Rapid Update 599

Grecale Premium Alarm System (LSA) OPT – Volumetric Alarm Deactivation

DATE: FEBRUARY 21 2023

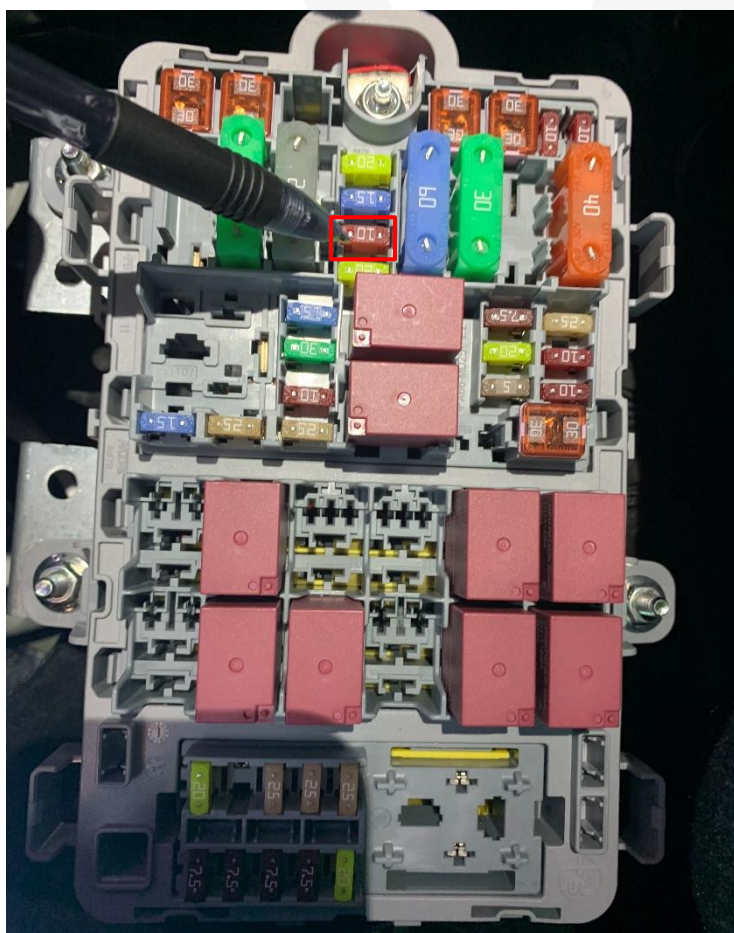
1. Always check ModisCS+ to see if the vehicle is involved in this action and if it has not been previously performed.
2. Write the new "**Vehicle Configuration**" (VC) through the MD-EVO.
3. Accessing the Rear Distribution Unit (**RDU**), remove the F14 10A fuse, indicated in the picture below.

NOTE: Please keep the fuse removed until a new Service action has been released to reactivate the volumetric feature.
